Request for NRC to Critique the Article on "Reducing the Hazards from Stored Spent Power - Reactor Fuel in the U.S."

April 18, 2003

I am one of the reviewers of the paper entitled: "Reducing the Hazards from Stored Spent Power-Reactor Fuel in the United States," and am also the principal author of the Sandia report that is cited several times by the authors of the paper. The subject of spent-fuel pool vulnerabilities is a very important one in the present day environment, and I am pleased to be able to provide input. I think the paper correctly points out a problem that needs to be addressed, i.e., the fact that a loss of water from a high-density spent-fuel pool could have serious consequences. However, I also believe the paper falls short of addressing all the considerations that accompany the problem. Some of these considerations could affect the results of the cost-benefit analysis that is used to justify the authors' proposed solution: the re-racking of the pool to a low-density, open-lattice arrangement and the removal of the older fuel to dry storage casks. In a nutshell, the authors correctly identify a problem that needs to be addressed, but they do not adequately demons

Figure 8: Neutron multiplication as a function of array pitch in an infinite square array of 4.4% enriched fuel rods with a design burnup of 53 MWd/kgU for 0, 25, 50, 75 and 100% irradiation (*Source:* authors).

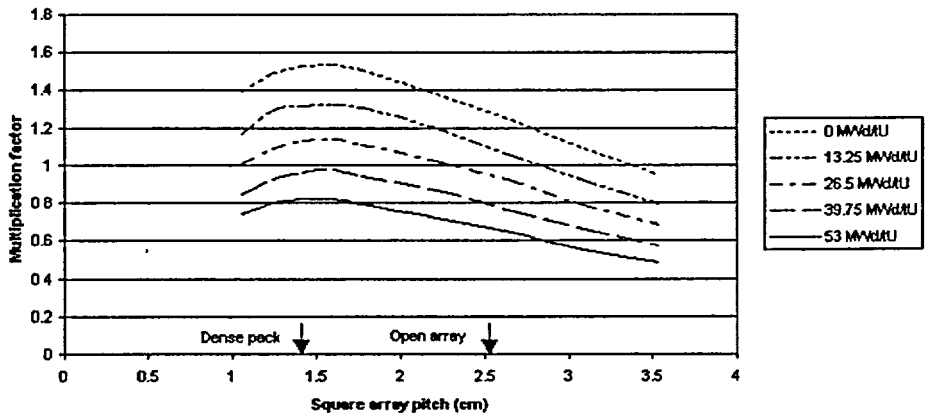
6. Page 20 discusses the potential for criticality accidents in open-rack storage if the fuel racks are crushed. Figure 10 is difficult to interpret because it has several unlabeled curves. But it is hard to envision a crushing event that would uniformly rearrange spent fuel in such a way that k-infinity calculations (which assume an infinite, uniform fuel lattice) are relevant to predicting the potential for criticality.
